Have Your Masks Been MWOed?

MWO 3-4240-347-20-1 (Jun 98) prevents the silicone rubber of the outlet valve housing from pulling loose from the facepiece.

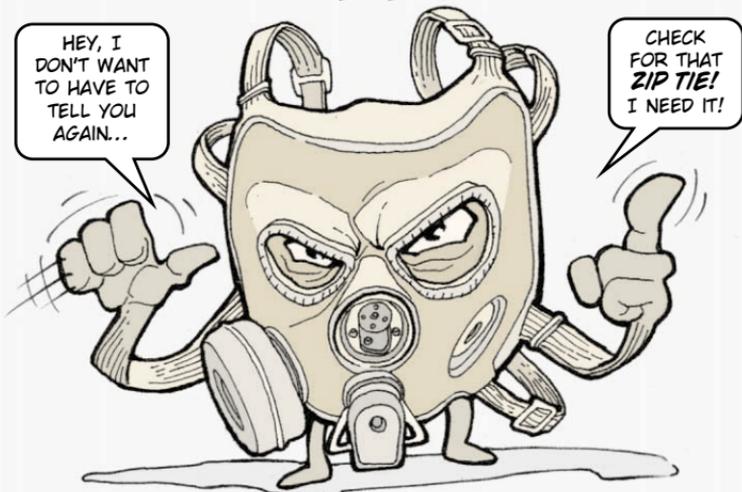
Not sure if your masks have been modified? Look at the outlet valve housing. If a zip tie has been fastened around the valve housing, the MWO has been done.

The tie should go against the face piece behind the drink tube nipple. If the tie's anywhere else, it can't do its job.

When you put on the zip tie, remember its tab should be in the 6 to 9 o'clock position. If you put it in anywhere in the 12 to 6 position, the drink tube gets in the way.
